AMENDMENT TO THE ASSESSMENT REPORT

For the Environmental Impact Statement for the IWS Northern Balefill

May 2005

Minister for Urban
Development and Planning

SECTION 1
SCALE 1:200
LONGITUDINAL SECTION THROUGH CONTAMINATED SOIL CELL

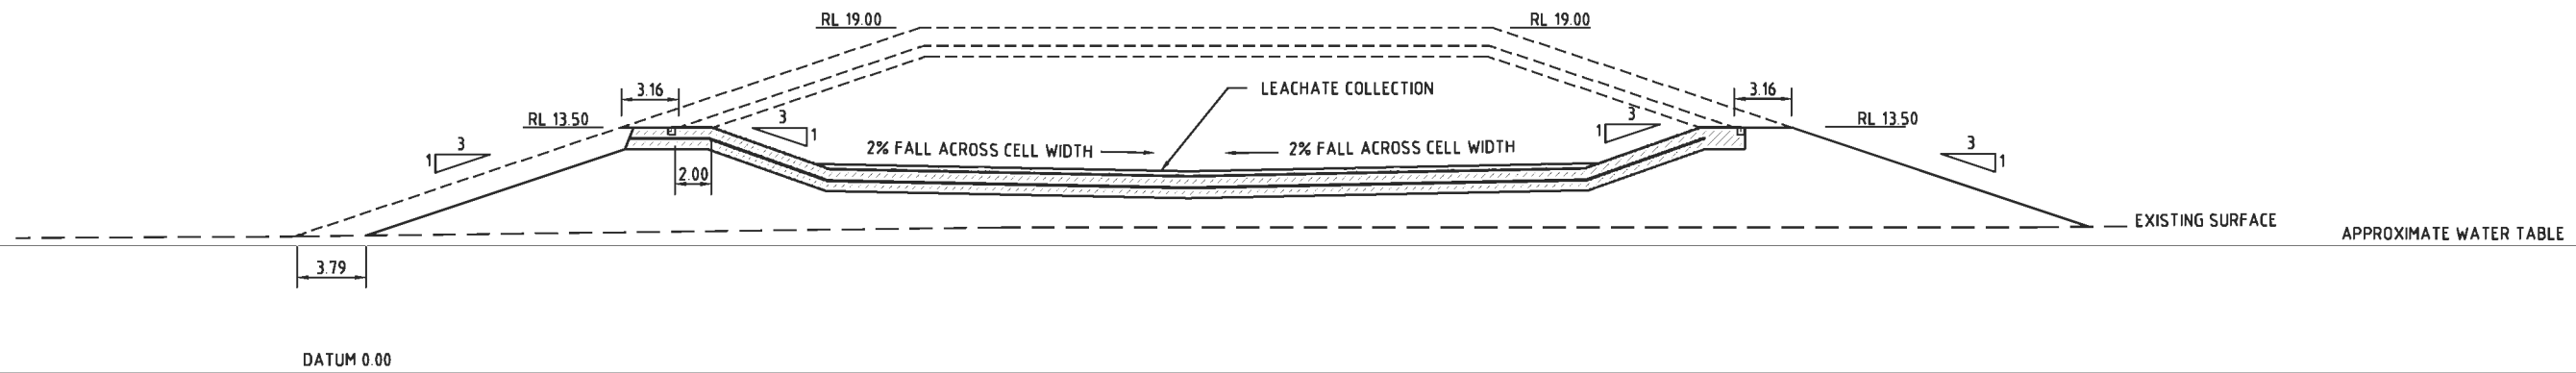
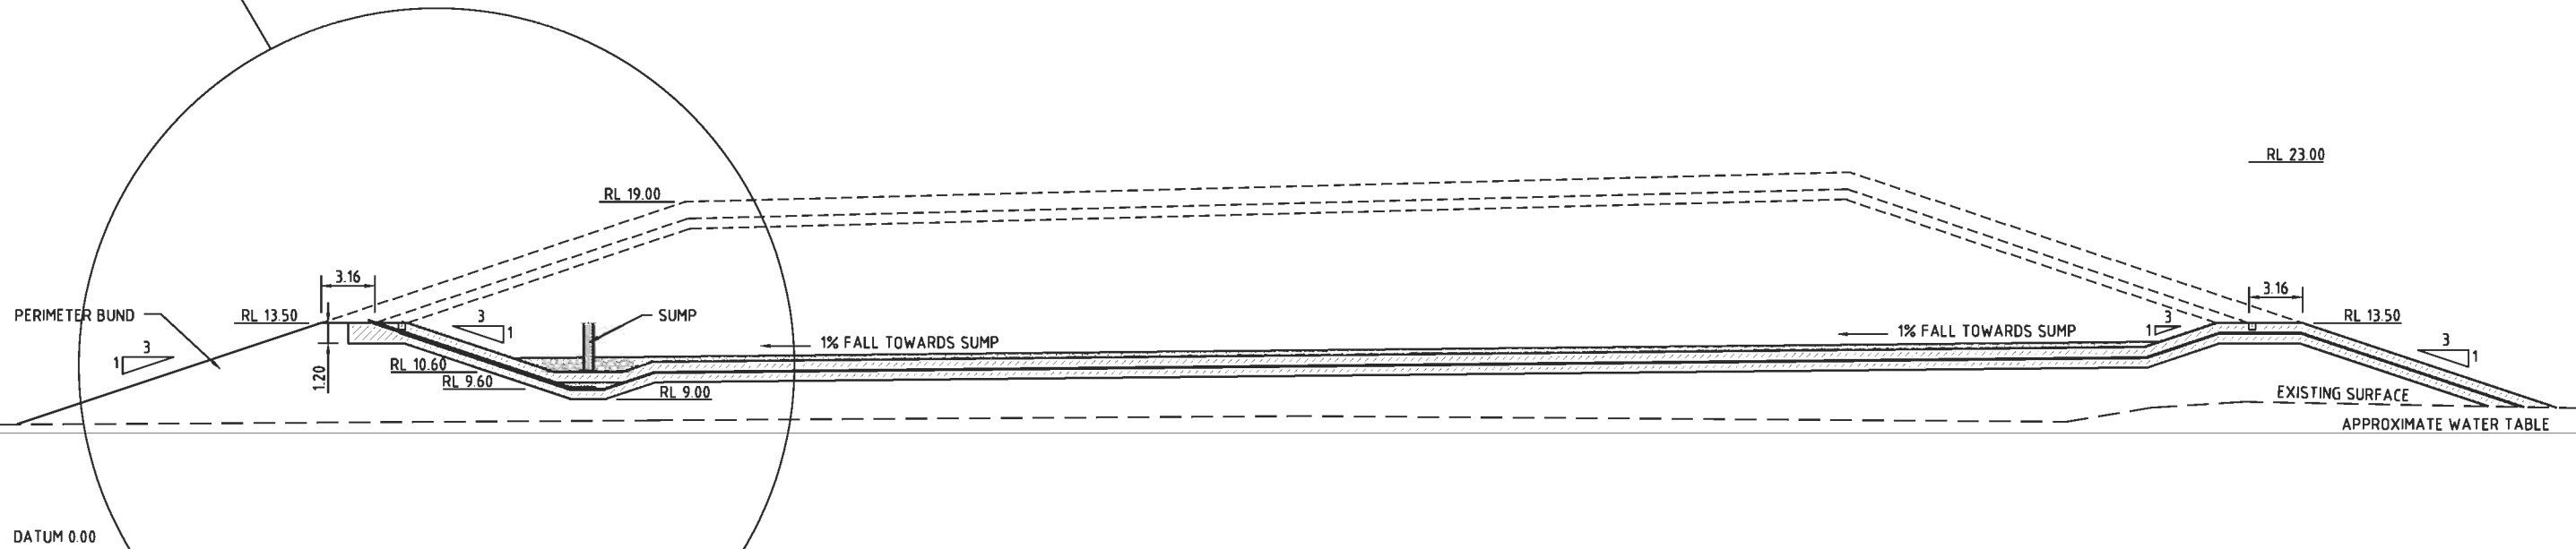
(t) Comment: Drawing 210225a-CO2: Clarification of the following is requested:

PROJECT	LOW LEVEL CONTAMINATED SOIL CELL	
DRAWING TITLE	LINER DESIGN SECTIONS AND DETAILS	
PROJECT No	04663307	DRAWING No 3307D03
REVISION	P1

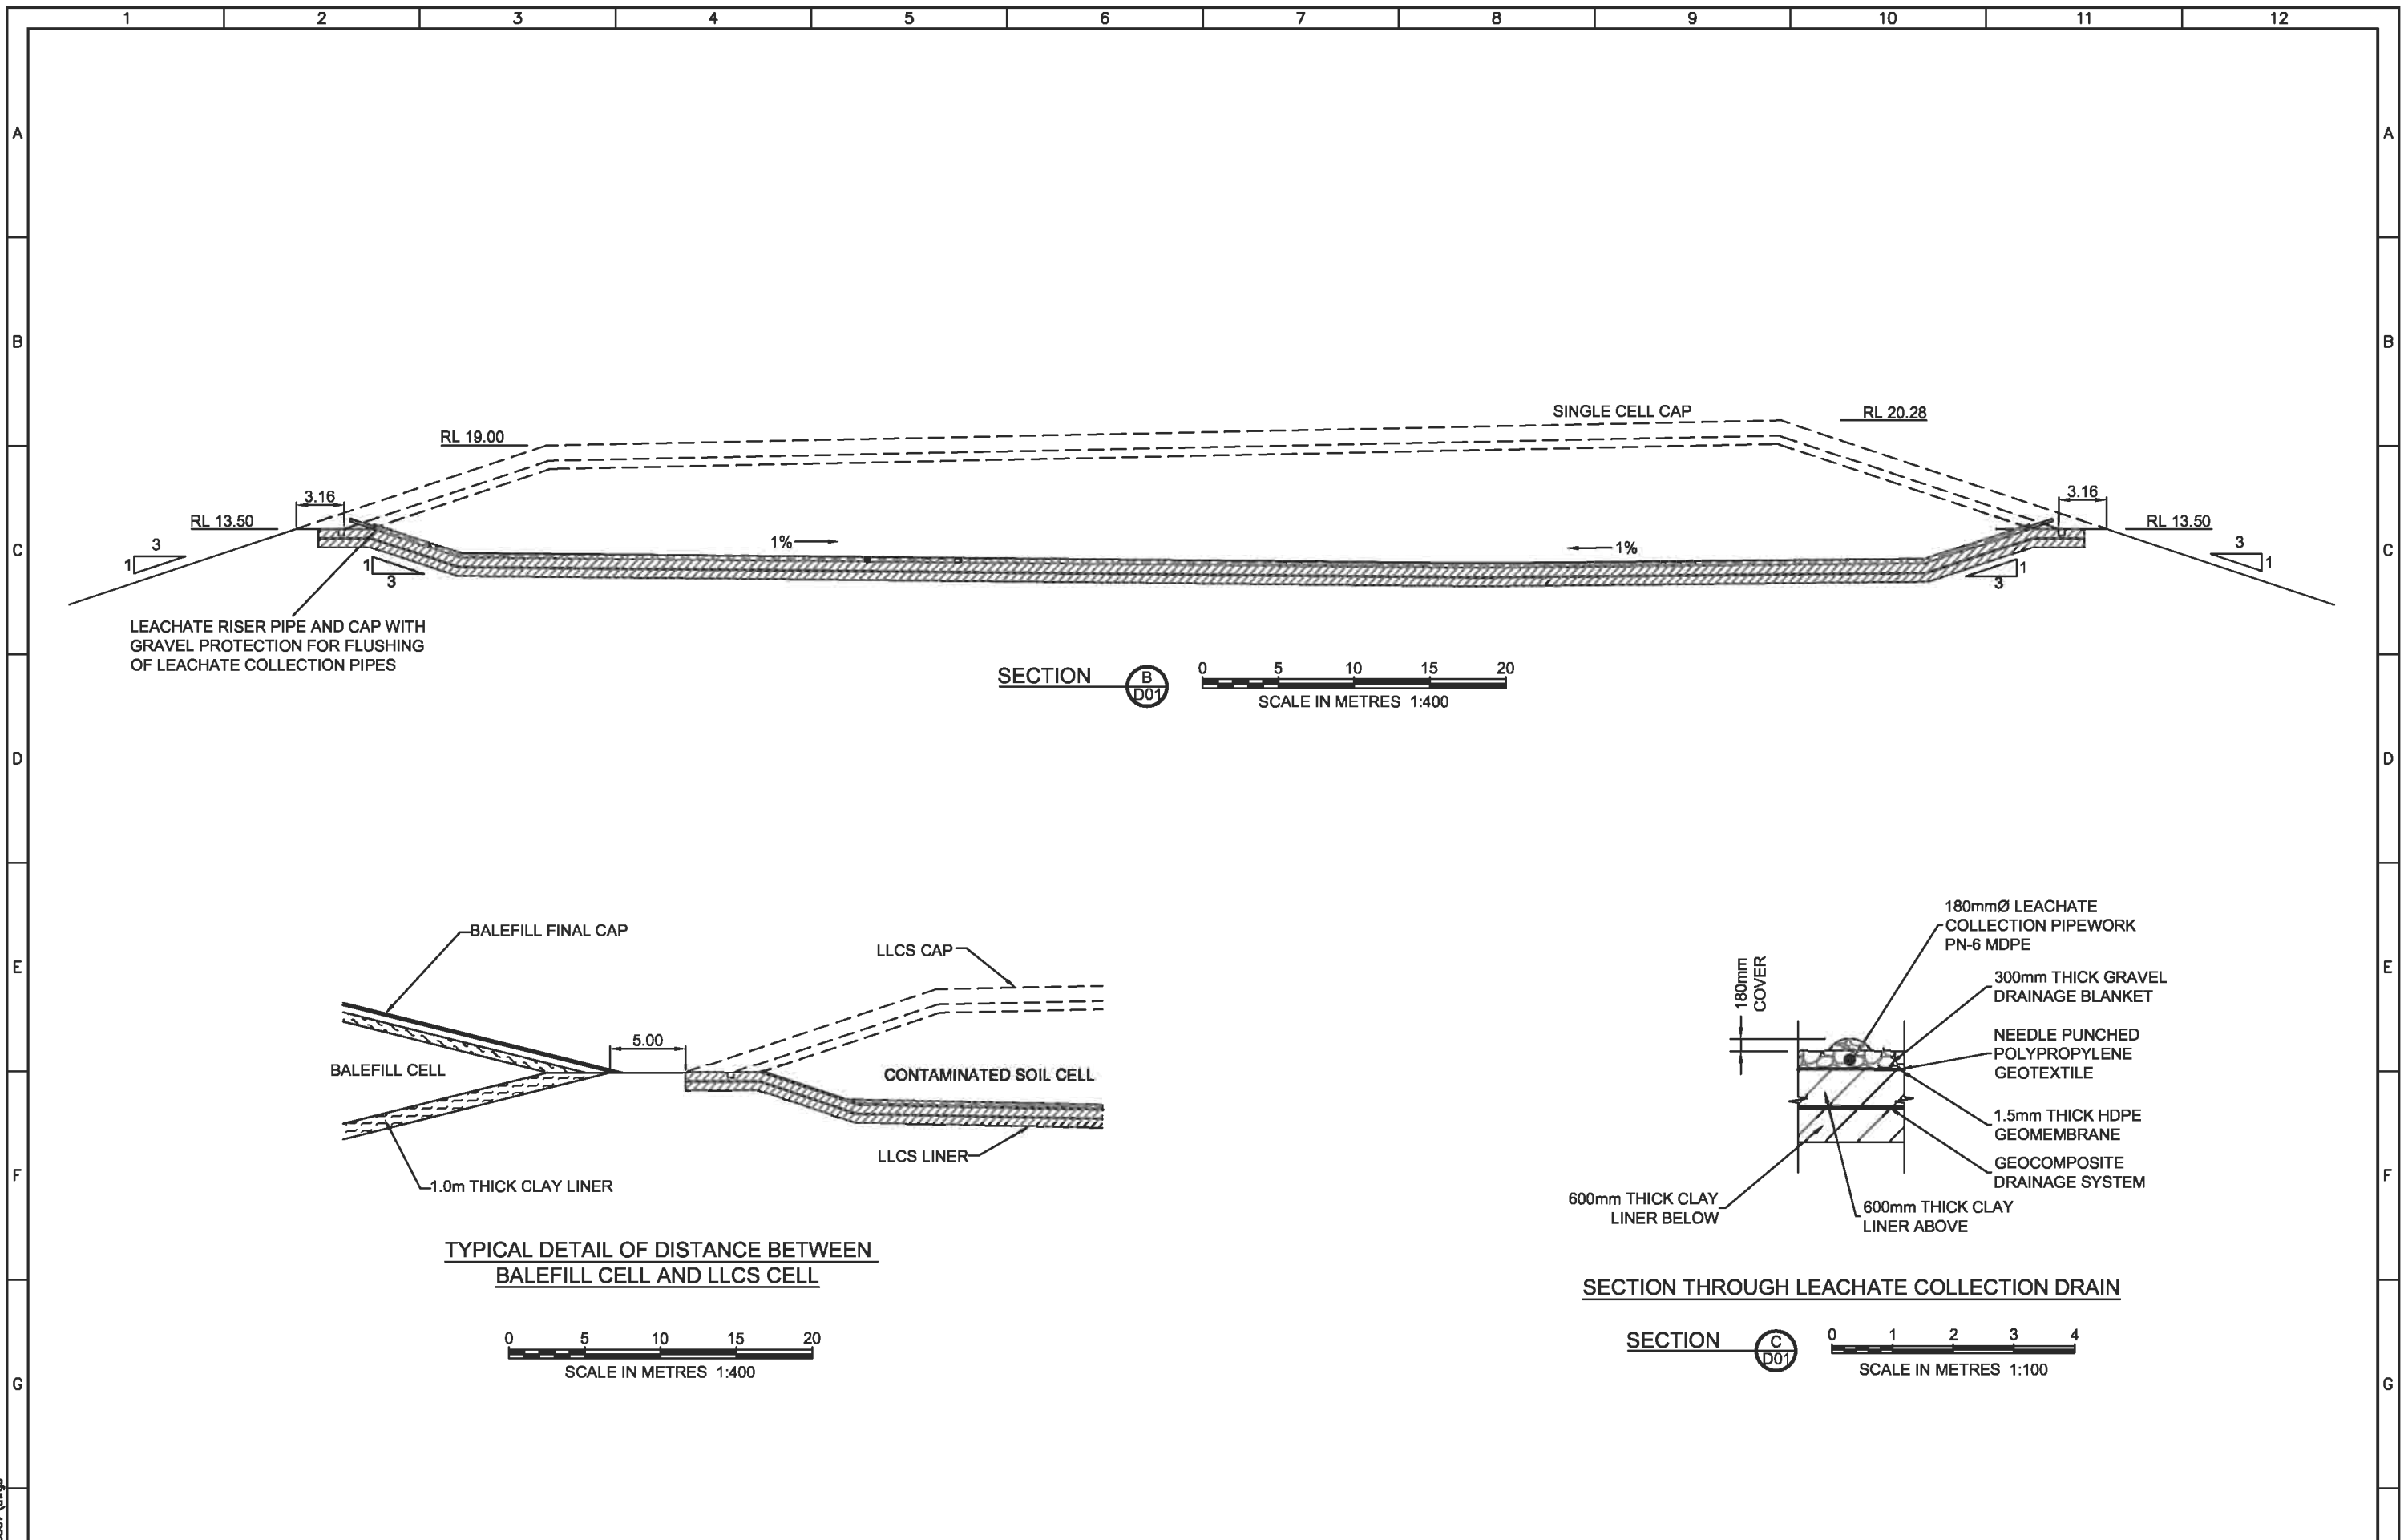
6 Distance between LLCS/LTPR Cell and Balefill cell (reference drawing 3307D03)

Distance between LLCS/TPR Cell and Balefill cell (reference drawing 3307D03)
